July 6, 2026

ADDENDUM 1

ARQ AVIATION

FLIGHT SCHOOL + FBO

PARTIAL FINISH PLAN
- AREA A

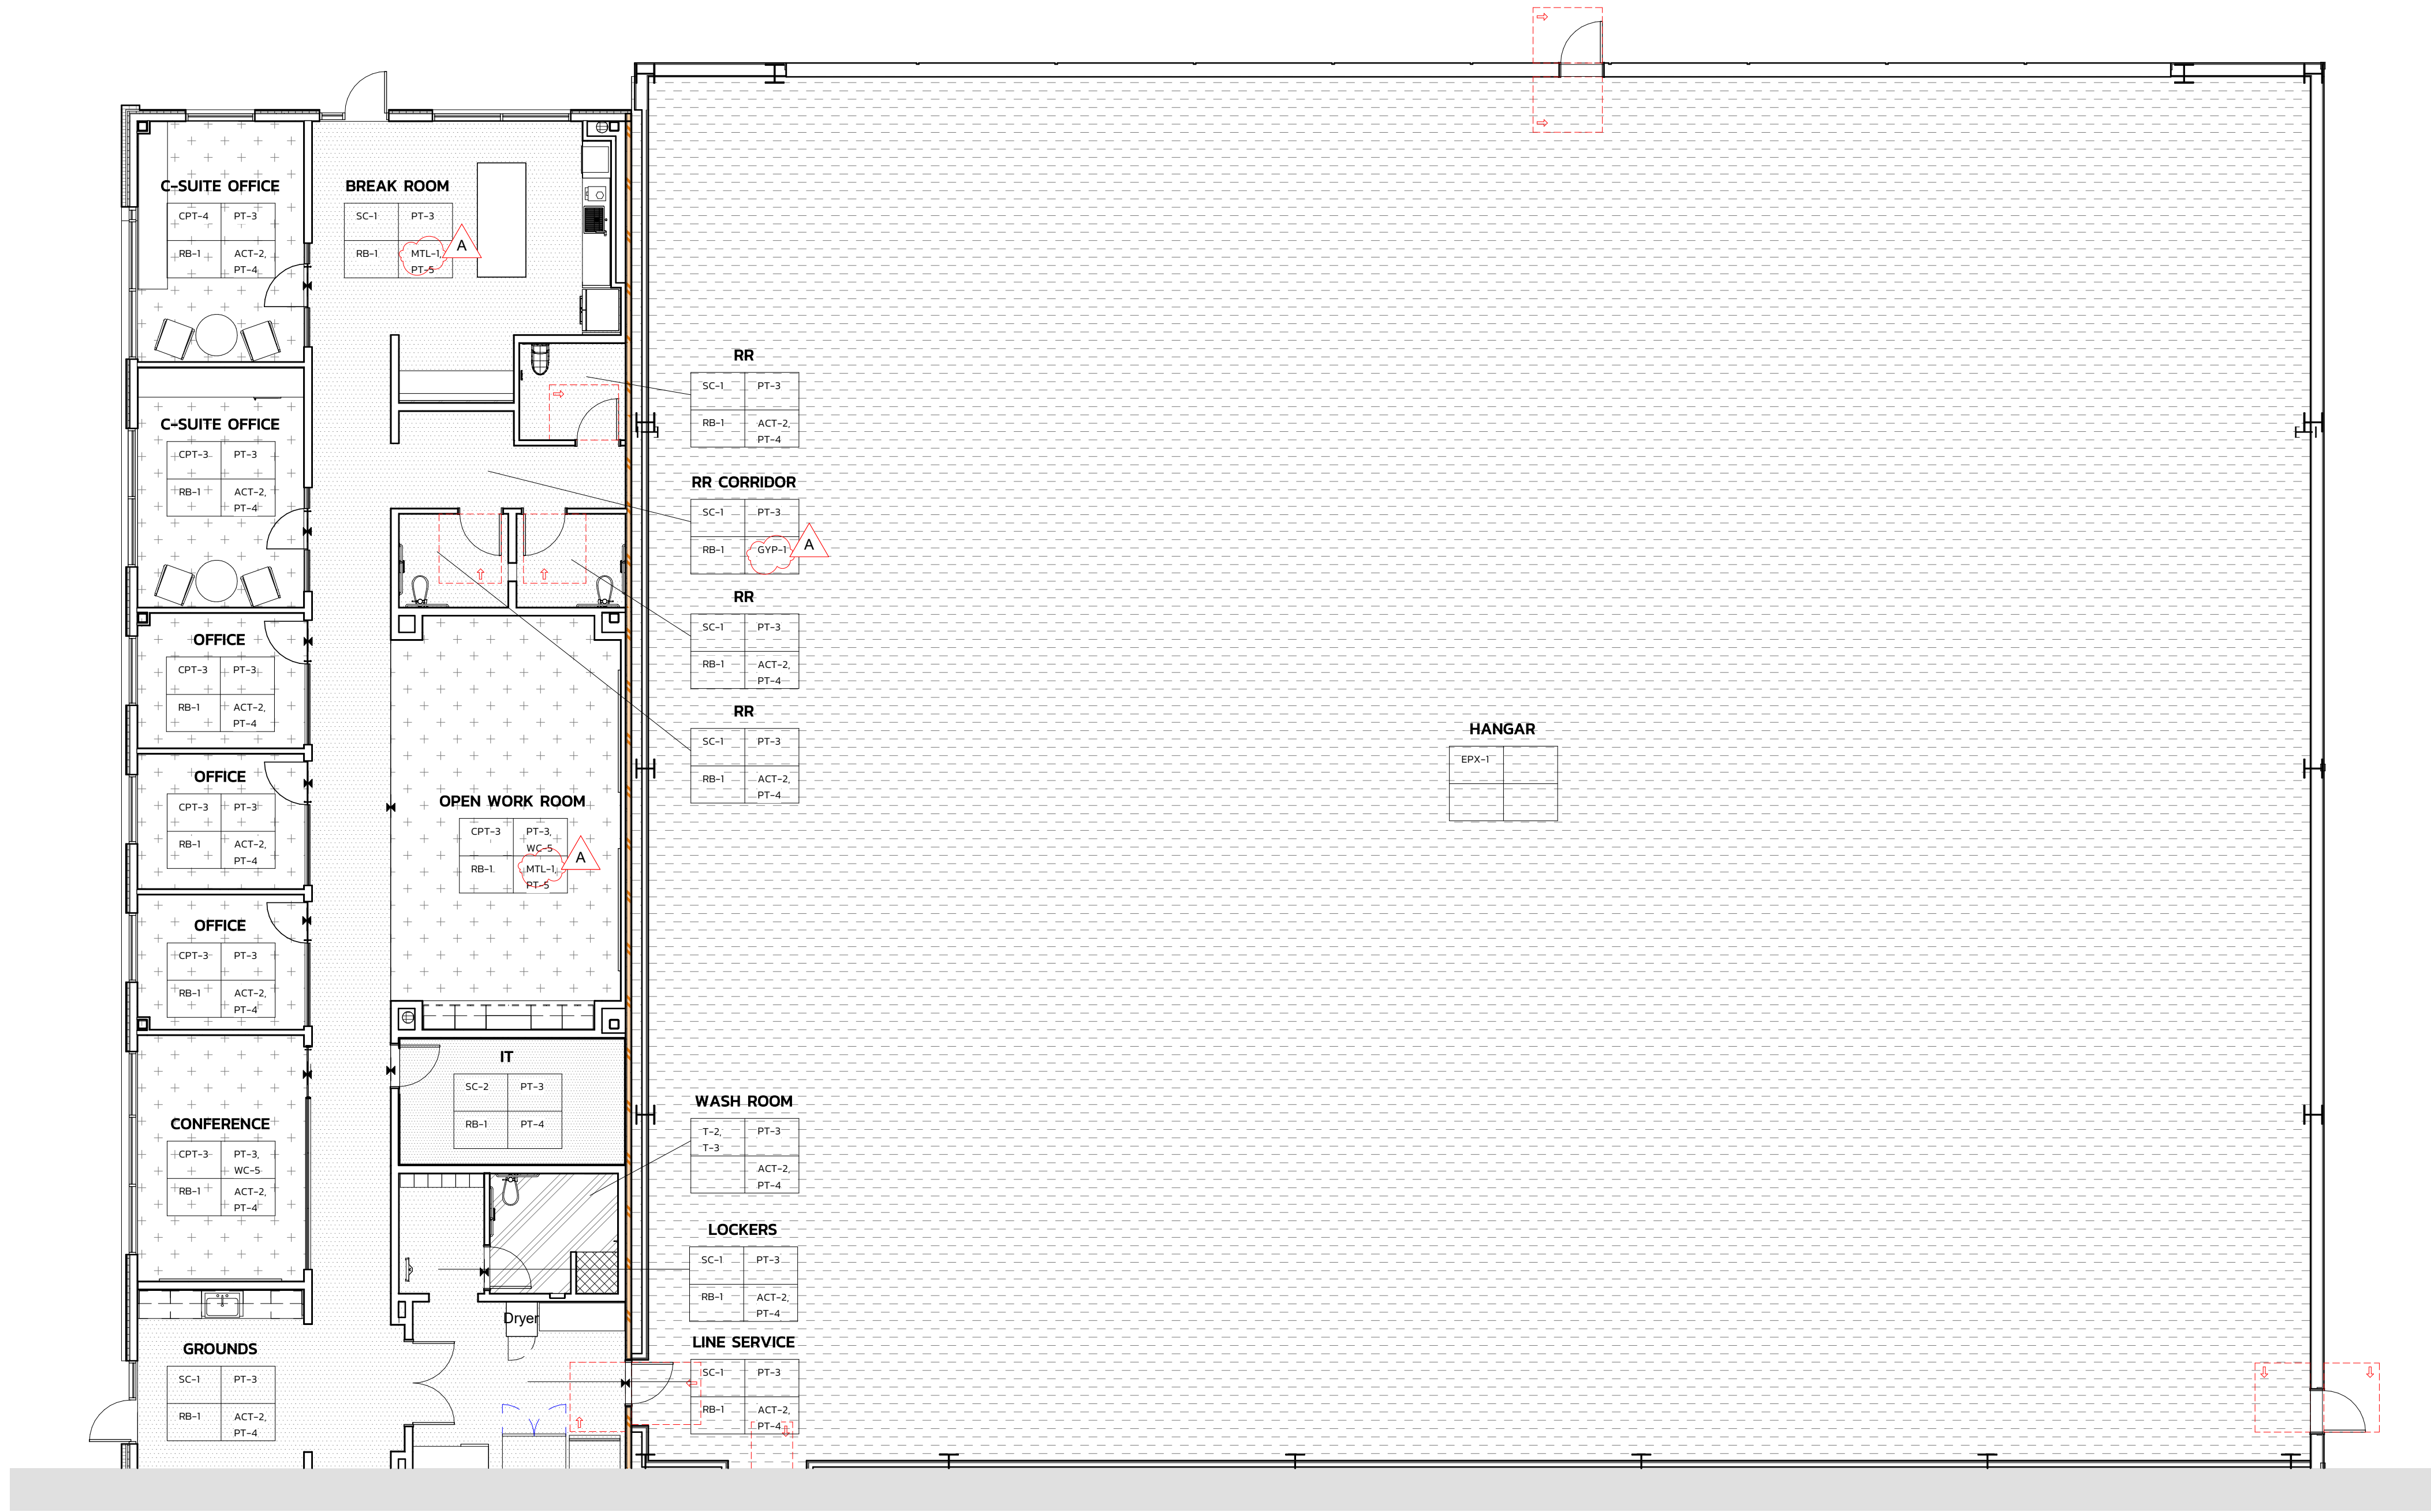
- Referencing Partial Finish Plans (Sheets A-711A & A-711B), there are certain areas that call out for "CPT-4". When referencing the Finish Schedule, there is no CPT-4 listed (only CPT-1, 2, 3, and WO-1). Please advise what item is desired for CPT-4. **Milliken Heavy Metal Alloy, Aly13*-220, Alluvial, Ashlar**
